ROOF REPLACEMENT CAPITAL PLAZA

FRANKFORT, KENTUCKY

REVISION NO. 1 11 APR. 2005

"AS-BUILT" NOTE:

DETAIL E 1/2 F.S.

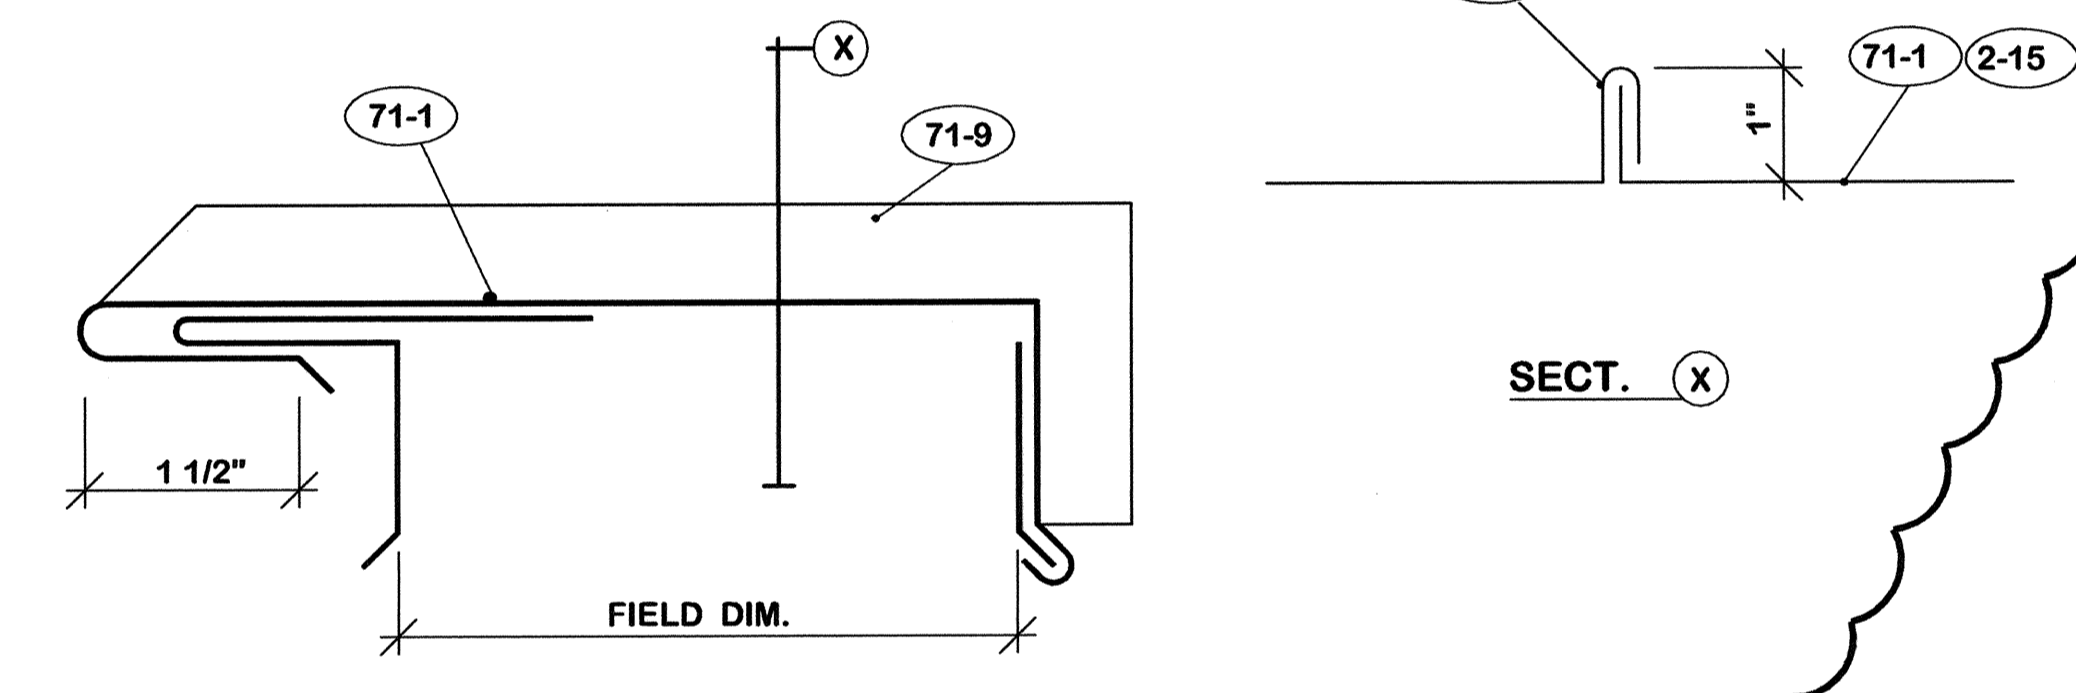
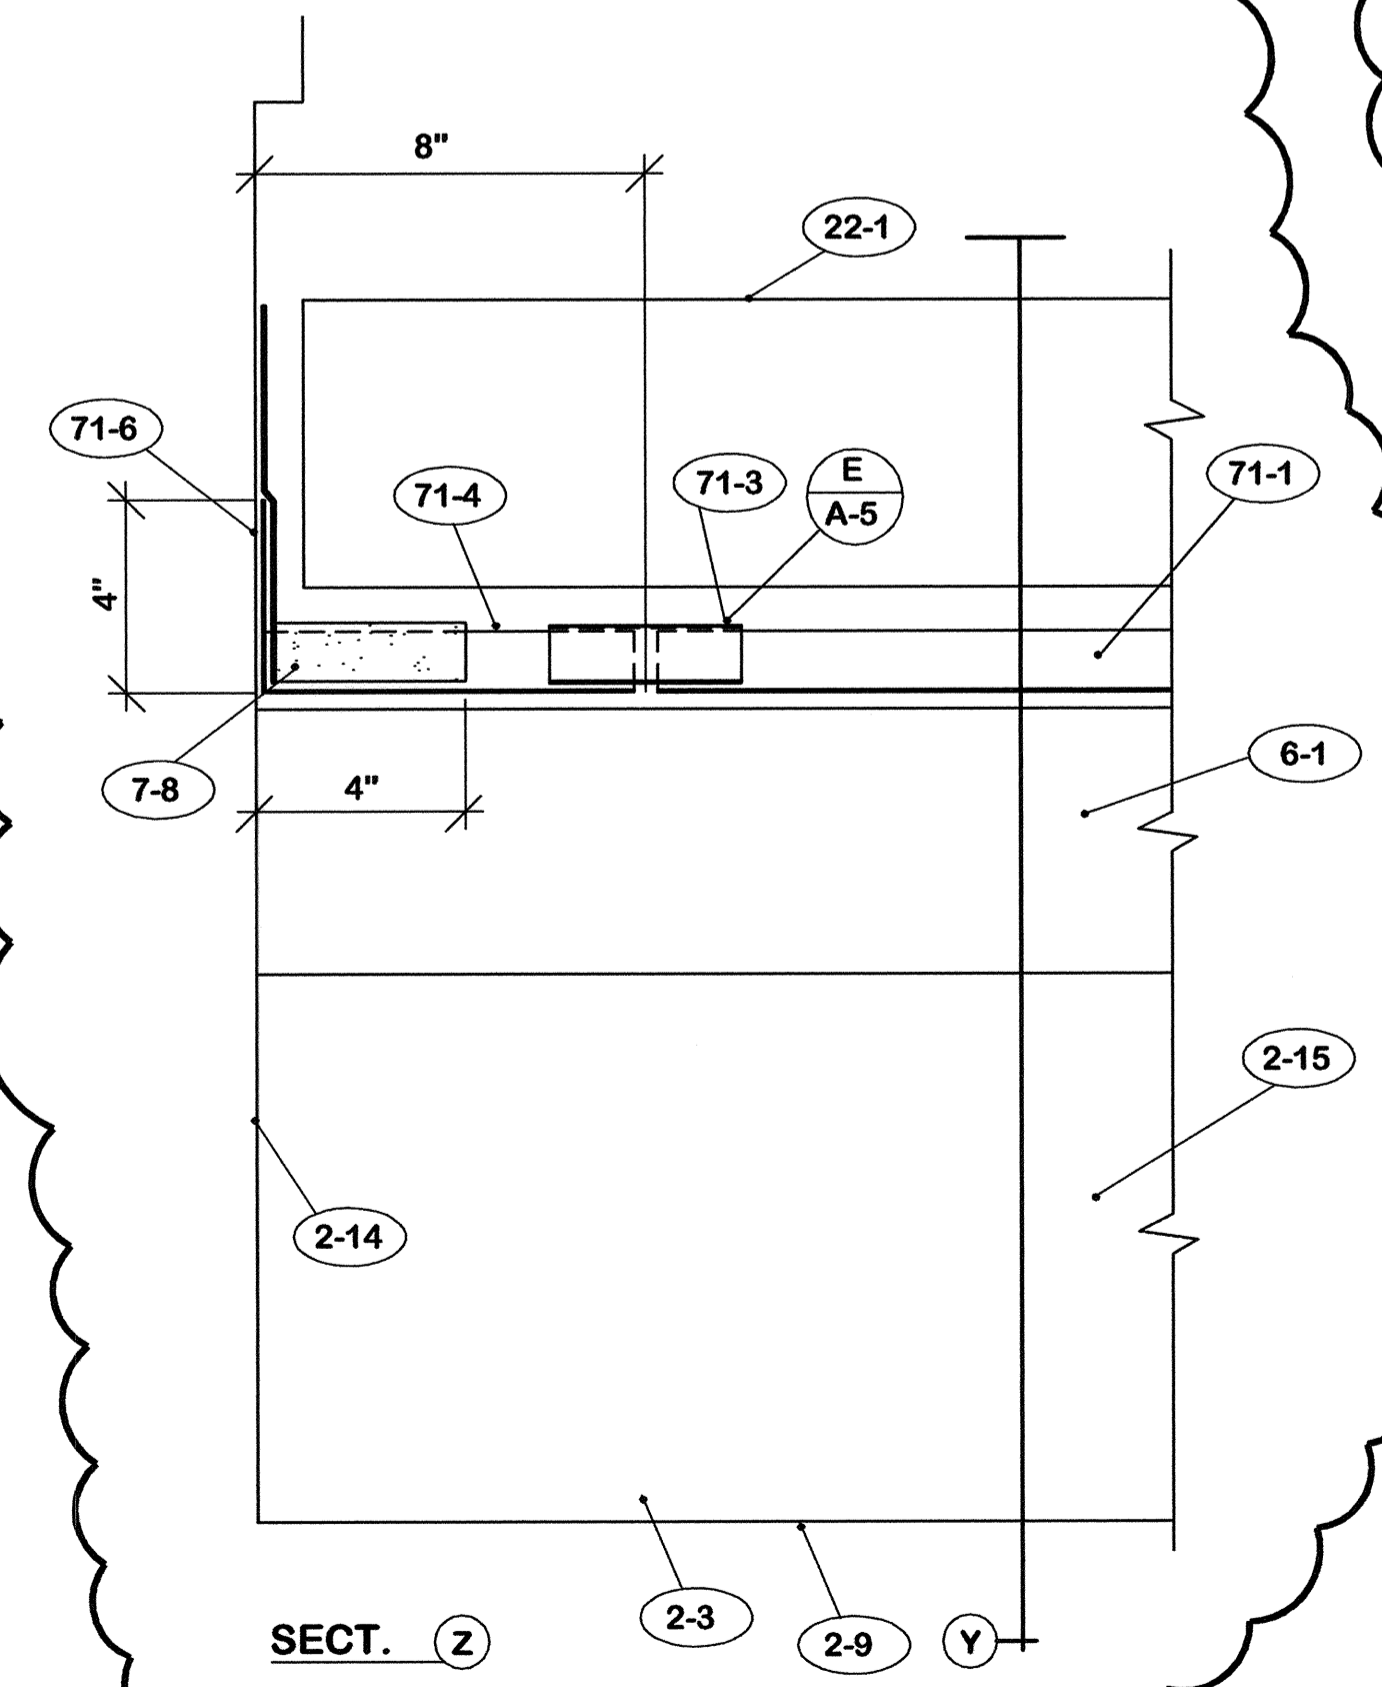
1. Delete plans A/A-5 & B/A-5.
2. Delete detail D/A-5.
3. Revise detail F/A-5.
4. Delete section F/A-5 (Z).
5. Revise section C/A-5.
6. Revise section E/A-5 (X).
7. Delete note series 6.
8. Delete notes 71-2, 71-3, 71-4, 71-5, 71-6 & 71-8.
9. Add notes 71-9 & 71-10.
10. There was not sufficient space between wood members to install insulation here.
11. This is actual profile of expansion cover originally installed.

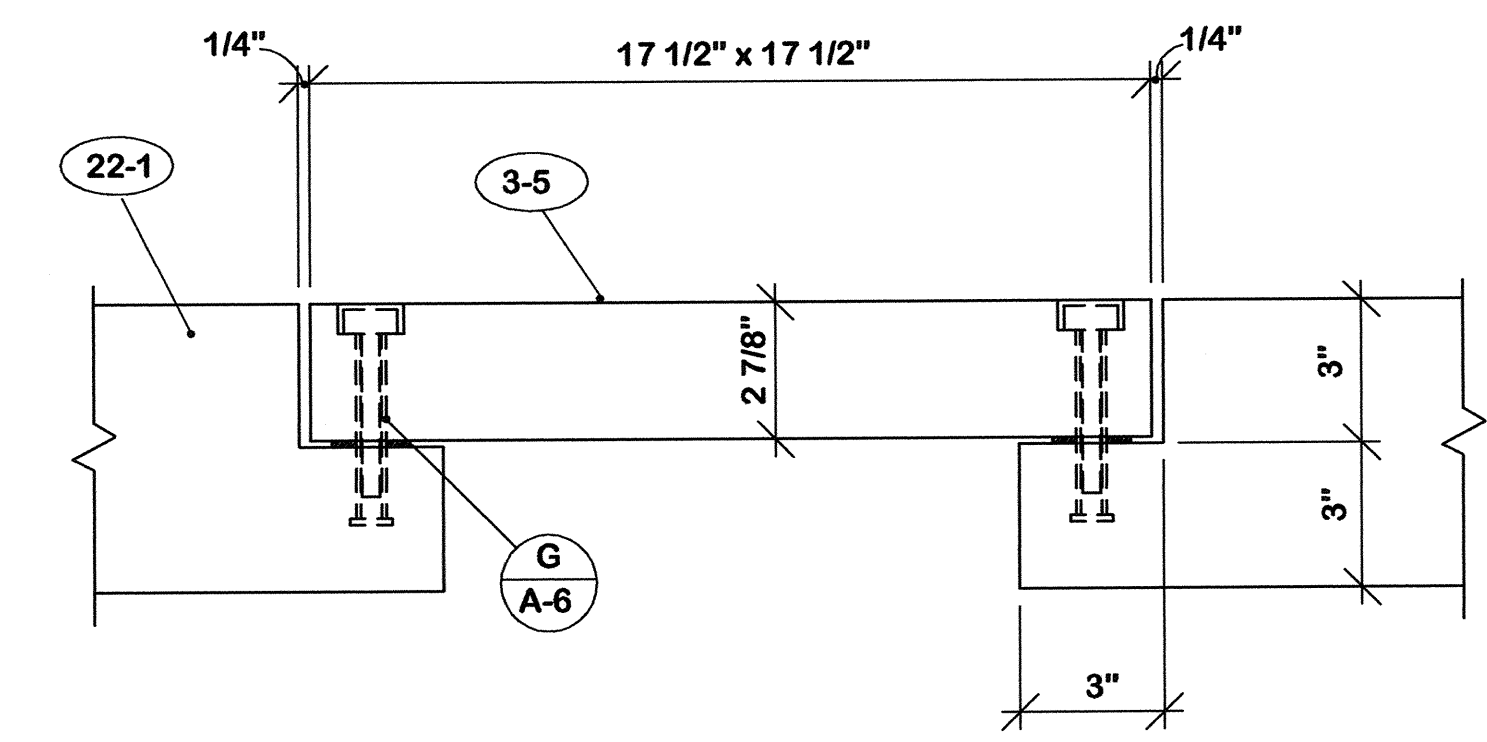
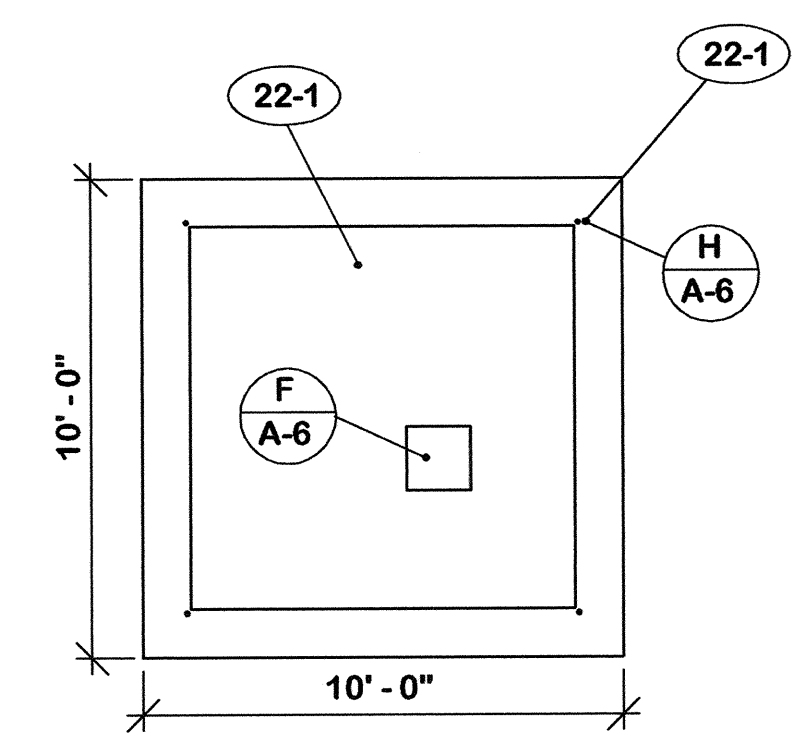
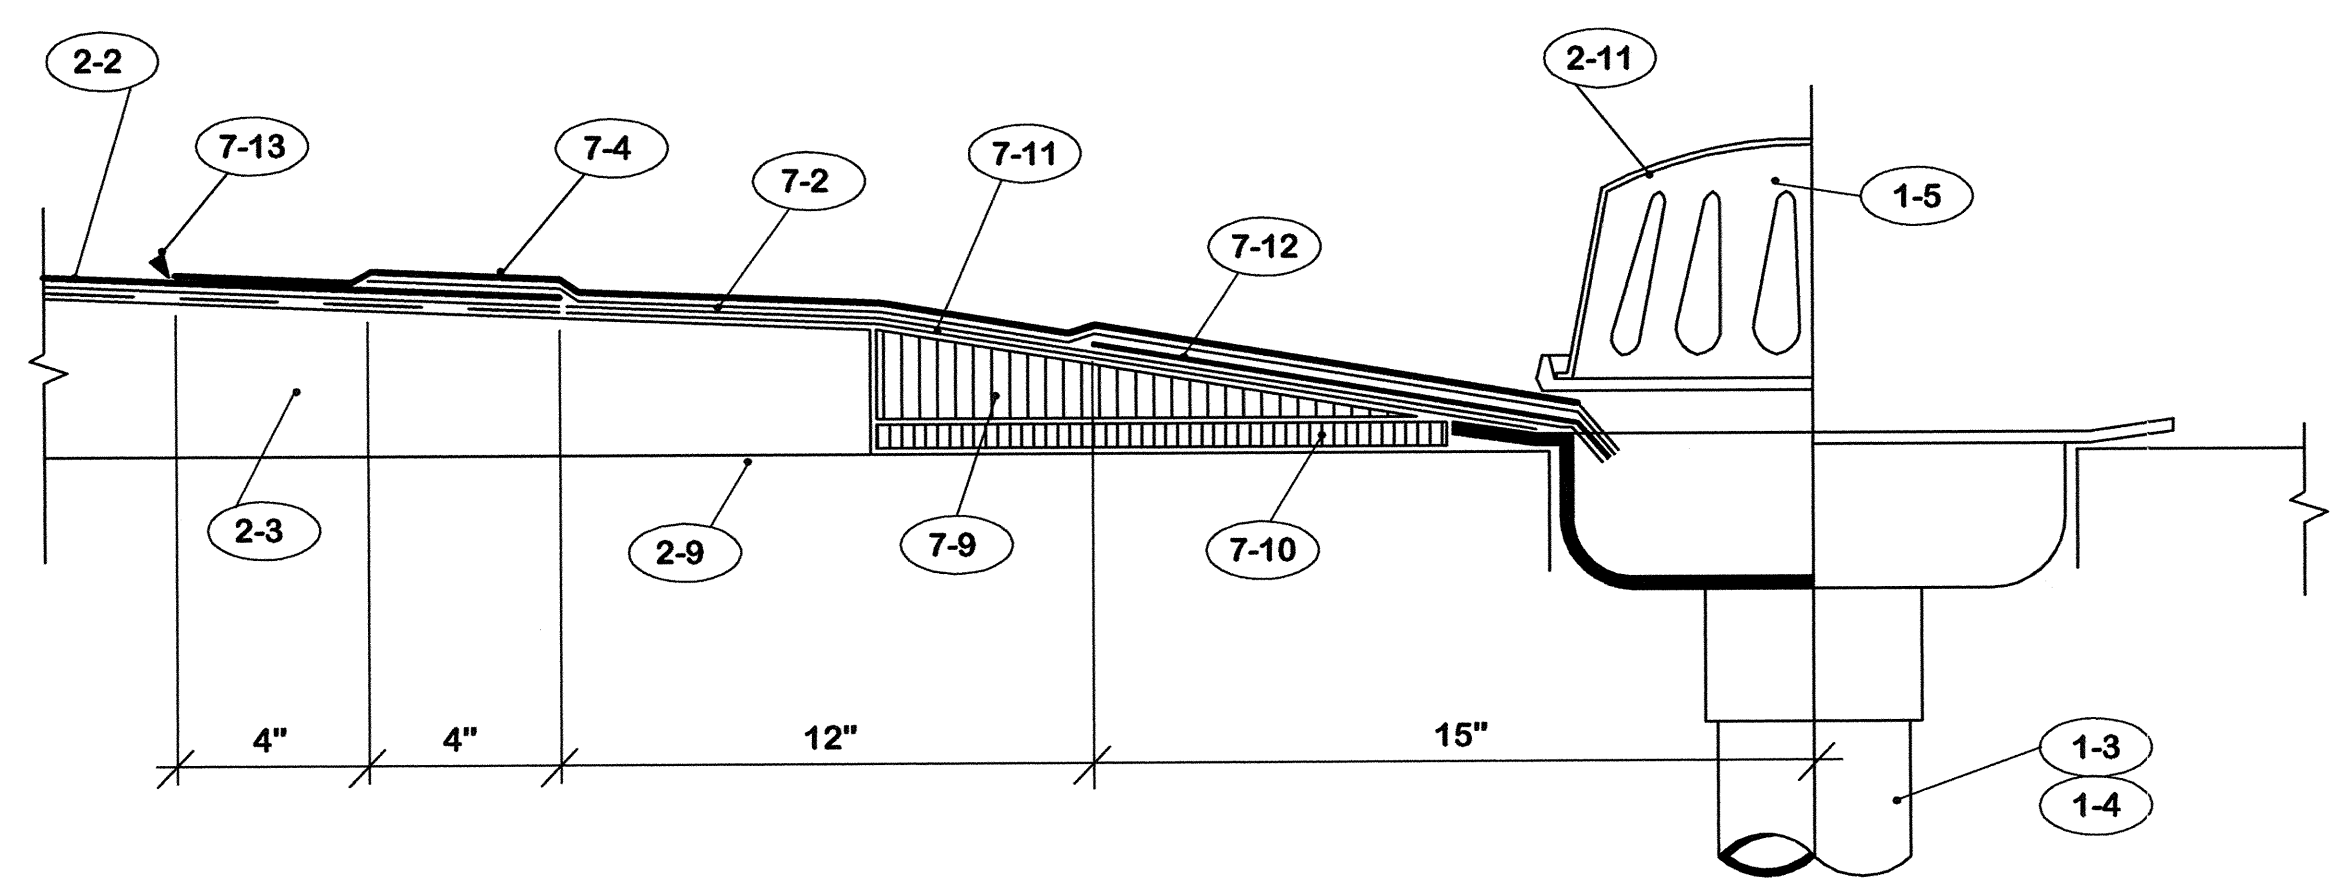
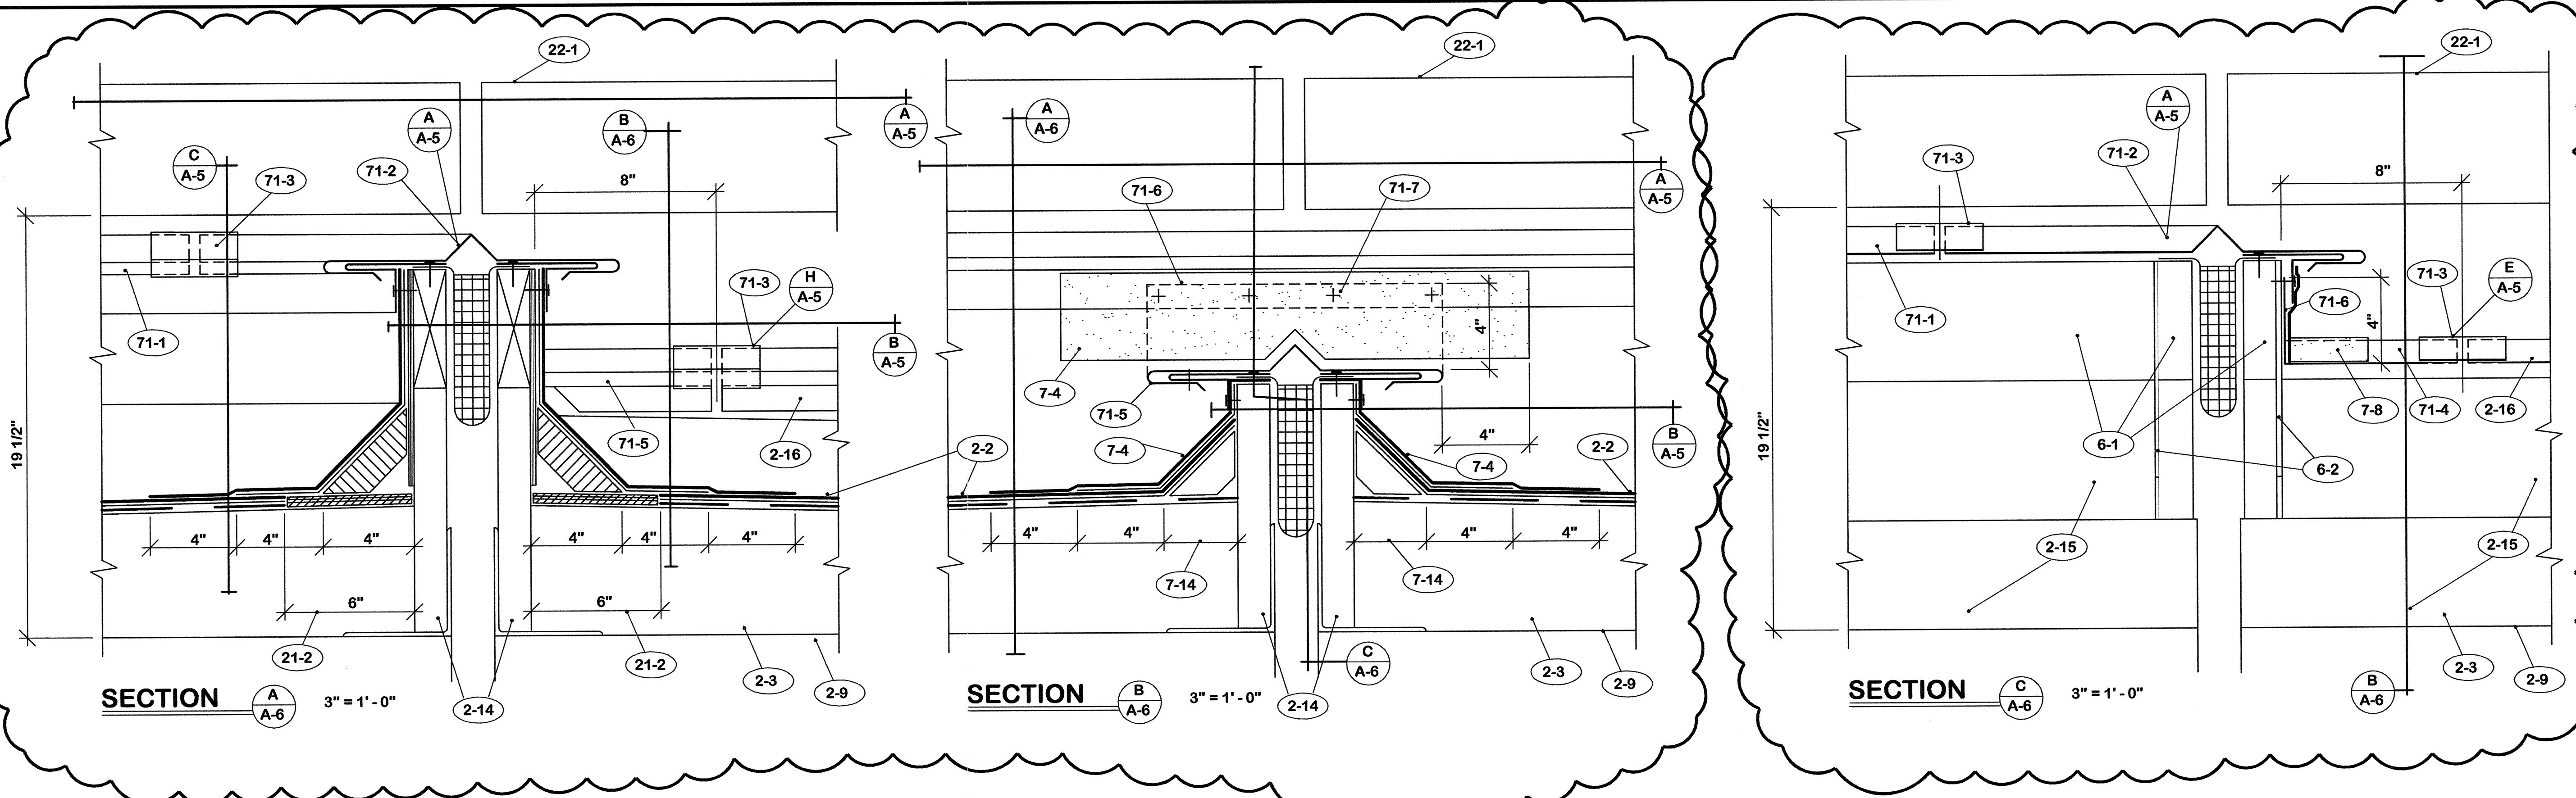
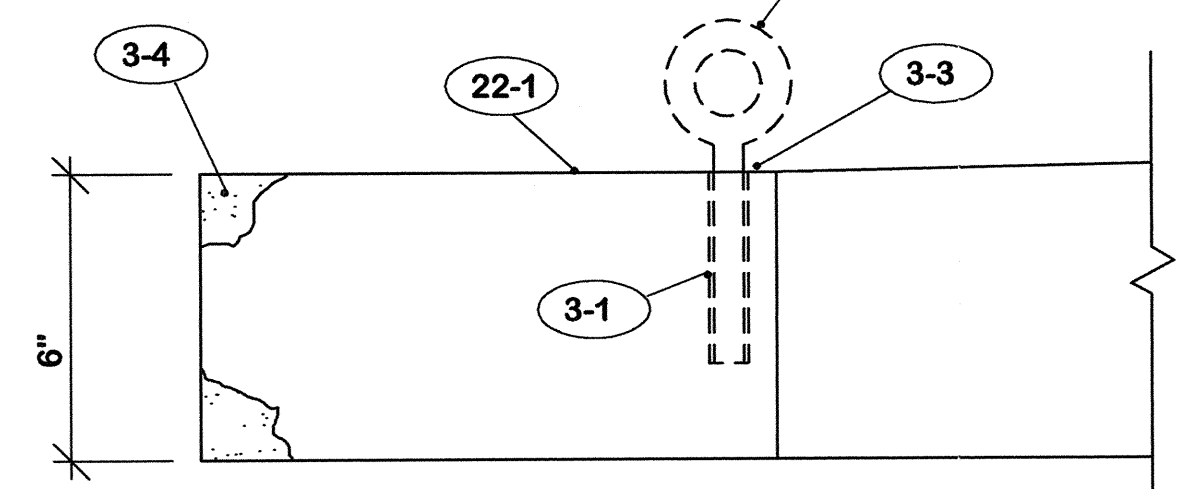
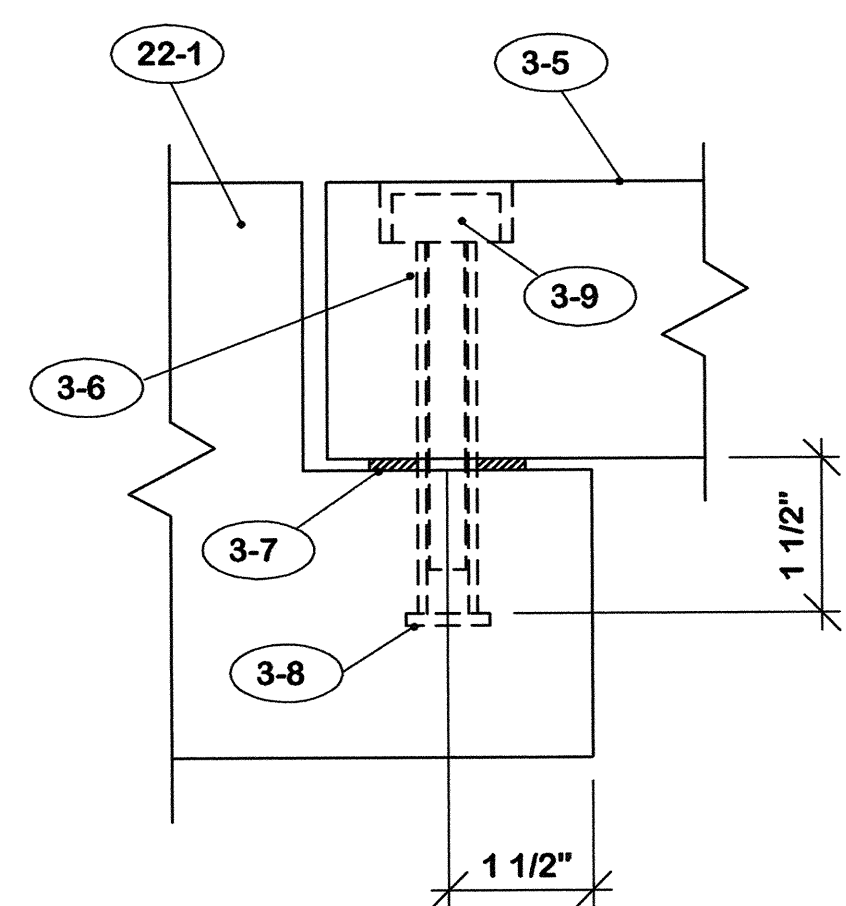
- Delete sections A/A-6, B/A-6 & C/A-6.
- Delete note 7-8.
- Add notes 7-16, 7-17, 7-18, 7-19 & 7-20.
